Replacement of 2433401 by 2433301

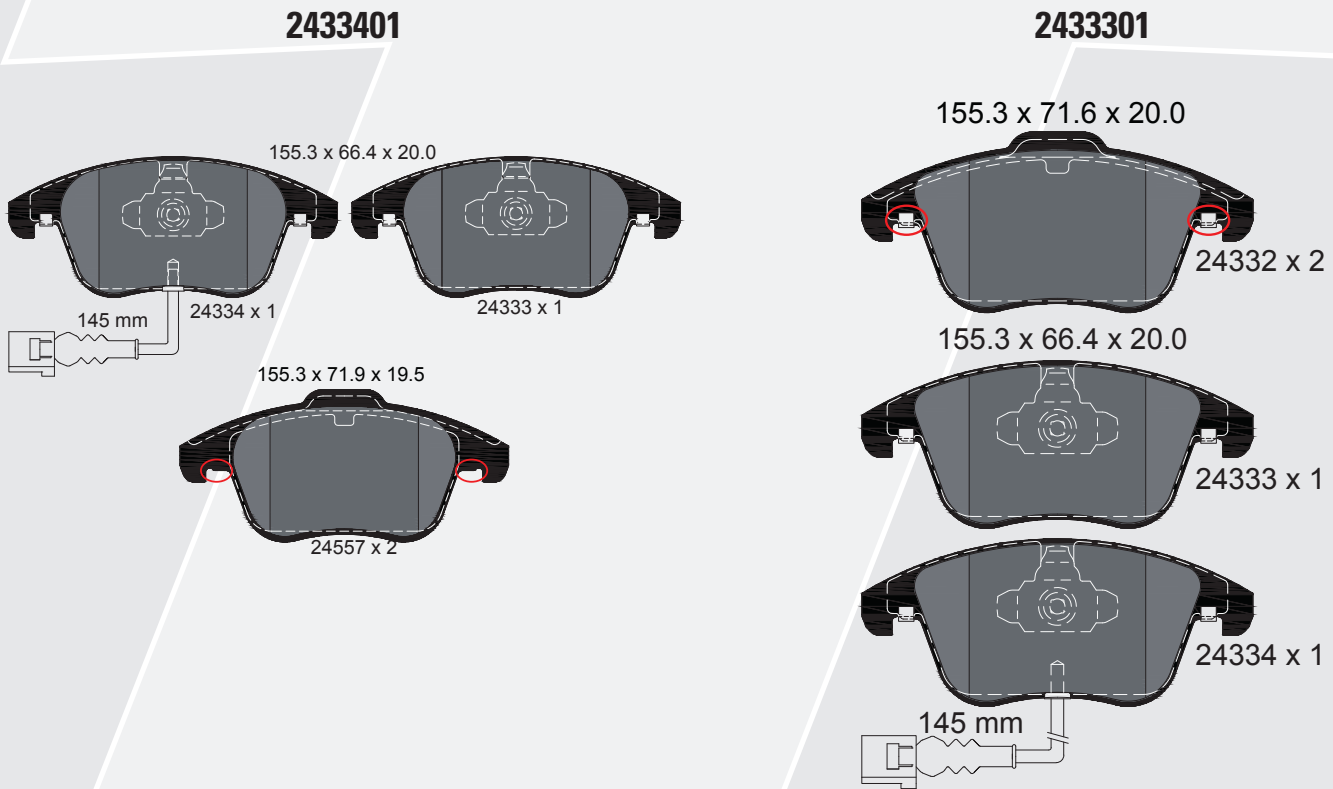
The differences between 2433401 and 2433301 are the wrap around shim in the sliding areas of the pads (see red marked areas in the picture below). All other dimensions are equal or almost equal and have no effect on the function of the brake pads. Therefore there will be no difficulties during installation and operation.

Textar is able to harmonize the references 2433401 and 2433301. It was proven that 2433301 can also cover the applications of 2433401. Therefore Textar will replace 2433401 into 2433301.
